Project
**GLADSTONE NICKEL PROJECT
ENVIRONMENTAL IMPACT STATEMENT
SUPPLEMENT**

Section 12**Environmental Effects of Residue Storage
Facility****9.3.3 Embankment Design (1)**

Figure: **9.10**

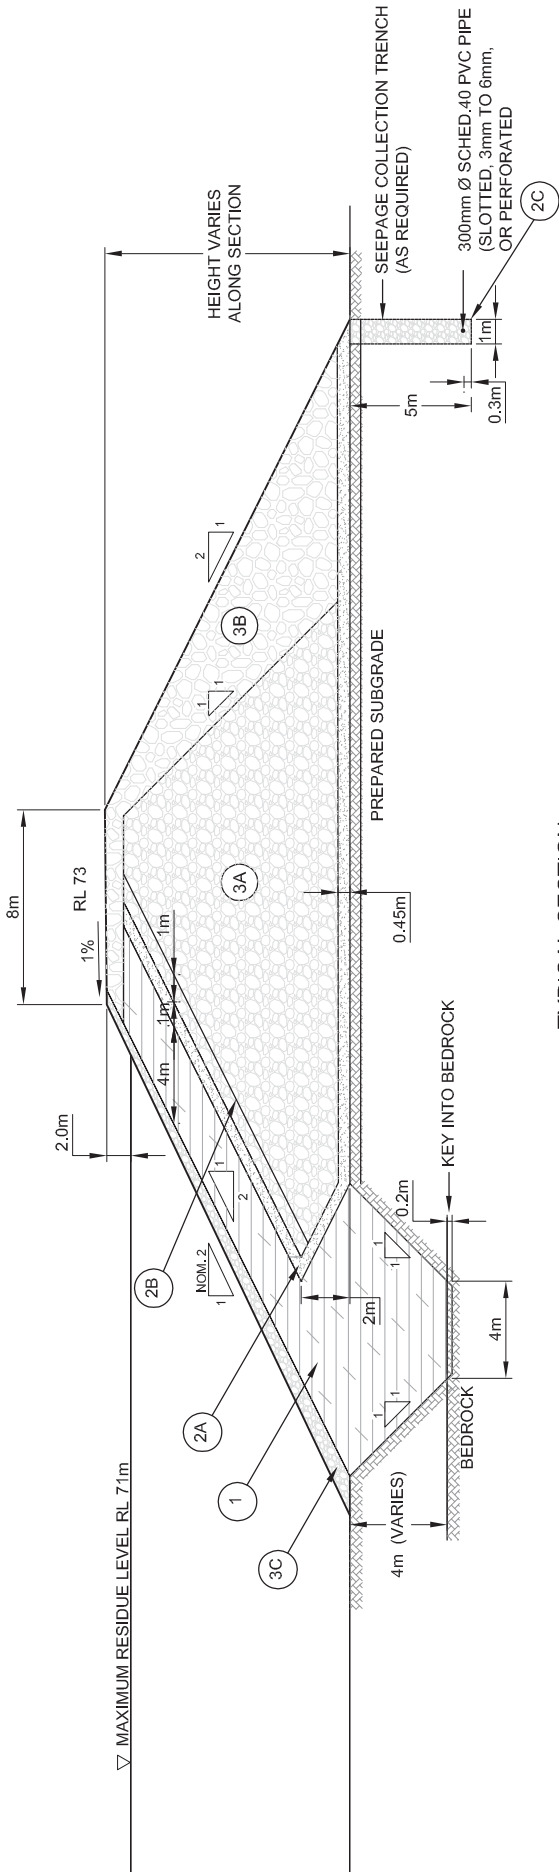
EPA advised that notes on Figures 9.3.3 and 9.3.4 should be altered as follows: For Zone 1- delete the option of using a 10t vibratory smooth drum roller, and specify 98% proctor MDD; and - specify a maximum lift thickness of 150 mm. For Zone 2A: specify a required filter criteria for the Filter Sand. For Zone 3A: specify a Maximum Lift Thickness of 500 mm.

The embankment design has been revised to meet or exceed the recommendations set forth by EPA. Figures 9.10 and 9.11 specify the following changes to the requirements for the RSF-A embankment fill placement:

- Zone 1: Compaction shall be by 10 t vibratory smooth drum roller, compacted to at least 98% proctor MDD; and the maximum lift thickness is set at 150 mm.
- Zone 2A: Filter sand shall comply with the "Filter Criteria for 2A" provided in Figure 9.10.
- Zone 3A: The maximum lift thickness is set at 500 mm.

Title PHREATIC SURFACE OF RSF-A AT END OF YEAR 1	
Figure: 9.12	Rev. A
	A4

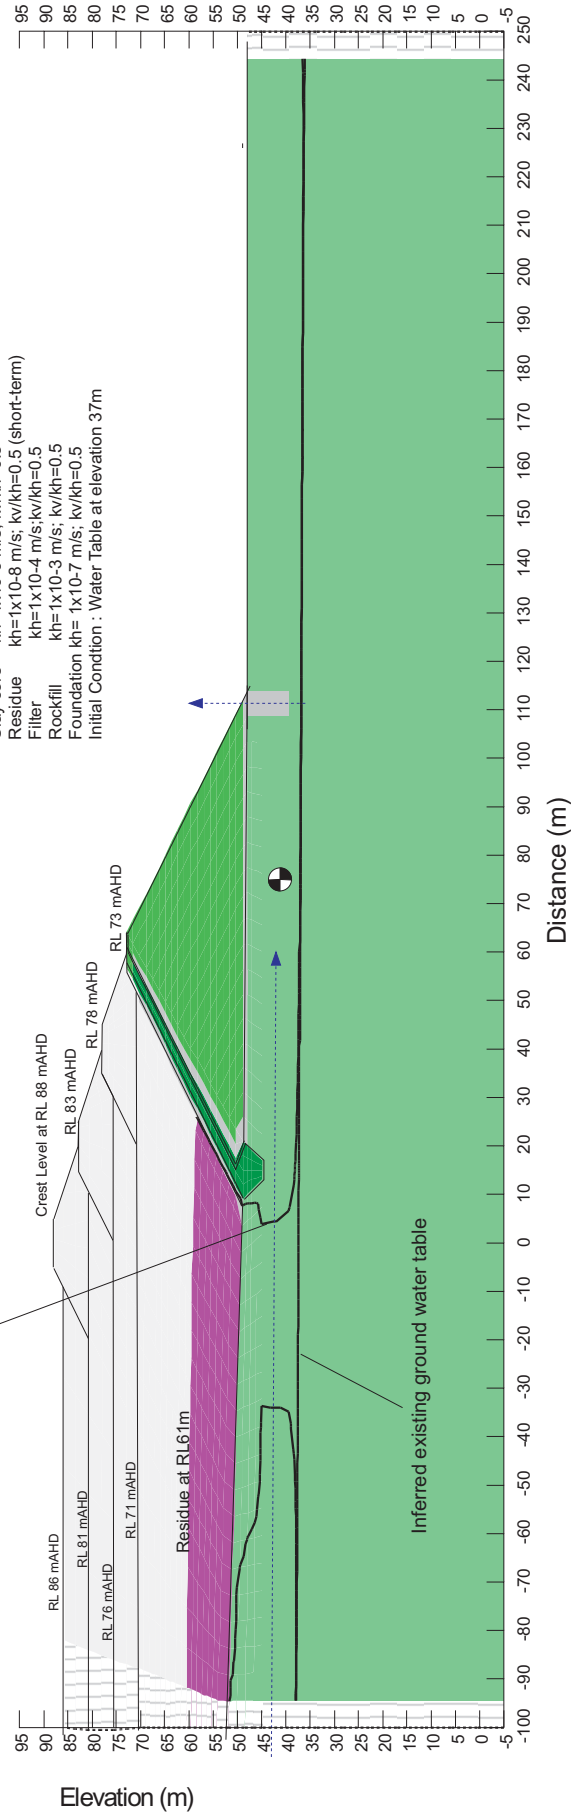
EPA advised that the EIS should include seepage in the water balance and discuss any potential impacts of this volume of seepage on the groundwater system, given the characteristics and composition of the supernatant liquor and potential leaching from residue solids.

For the RSF-A, a seepage analysis was conducted to quantify the amount of seepage reporting to the collection system. URS, 2007a reports the results of a seepage analysis that was conducted using SEEP/W (Geoslope, 2006b), a commercially available computer code that is designed to analyse steady-state and transient seepage under saturated and partially saturated conditions. Seepage was modelled both during operations (6 year life) and after closure of the RSF-A. A summary of the results for the proposed scenario of pumping from the collection trench after RSF closure is provided in Figures 9.12-9.16 and in the following table.

Client Gladstone Pacific Nickel Ltd 	Project GLADSTONE NICKEL PROJECT ENVIRONMENTAL IMPACT STATEMENT SUPPLEMENT		Title CONCEPTUAL FUTURE RSF CELL AREA	
	Drawn: VH Job No.: 4262 5791	Approved: CDP File No.: 42625791-g-267.dwg	Date: 29/01/2008	Figure: 9.17

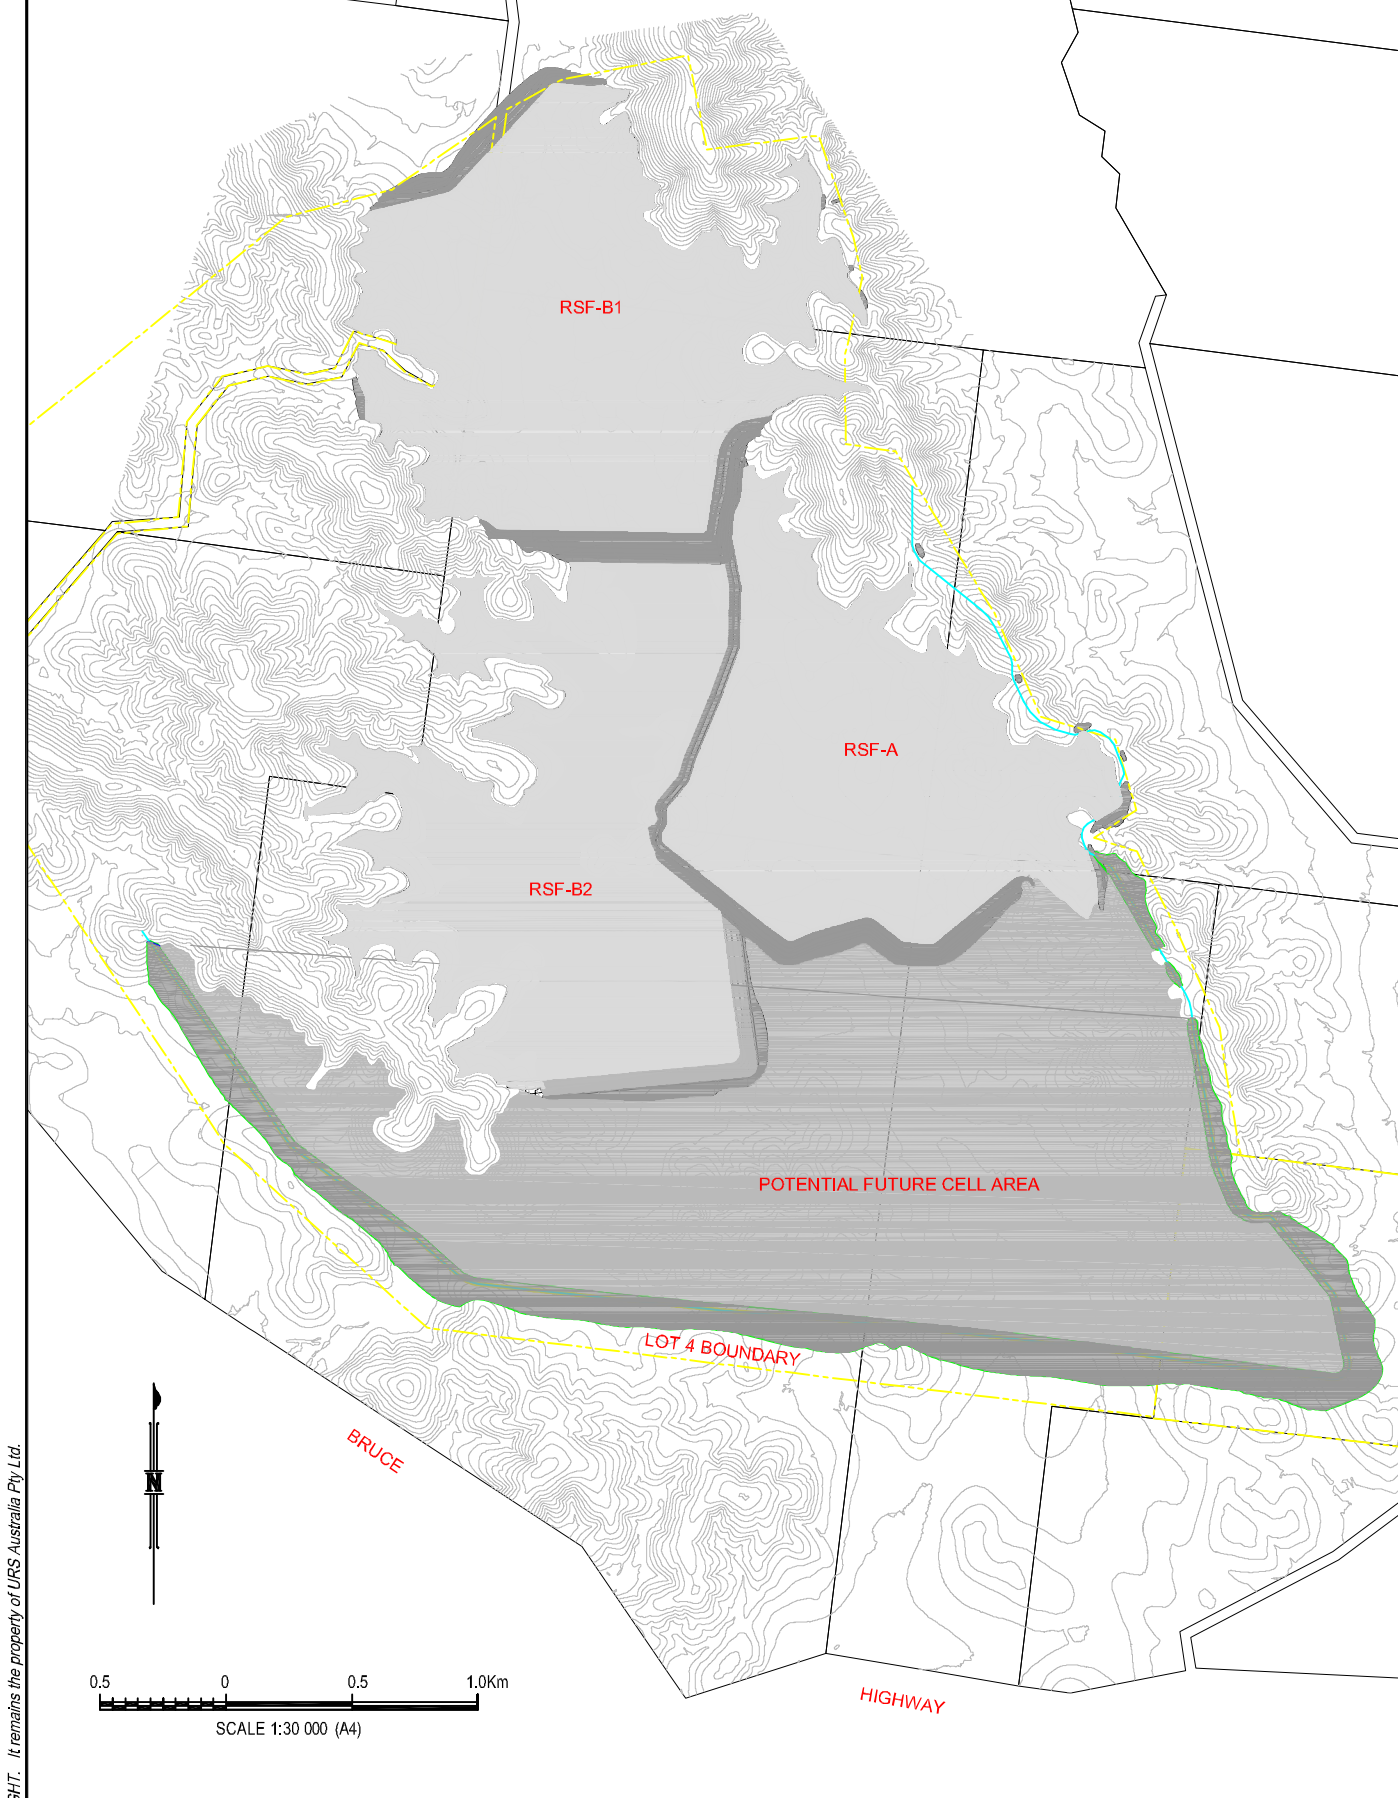
(13) DNRW advised that the EIS indicates that the storage will result in a reduction of mean annual flow within the Farmer Creek catchment. The Department has serious concerns regarding what impacts this will have on the catchment with particular reference to entitlement holders downstream. The EIS recognises that the one entitlement holder on Farmer Creek will be seriously affected and that an alternate water supply may be required, however the EIS does not adequately address this issue and does not outline any options for mitigation.

GNPL is also studying the use of the land to the south of the currently proposed cells, which could lead to an estimated additional 11% loss of catchment. A possible footprint for an additional cell in this area is shown on Figure 9.17. This is conceptual only and its feasibility and design are yet to be confirmed. No approvals are currently being sought for this possible future cell.
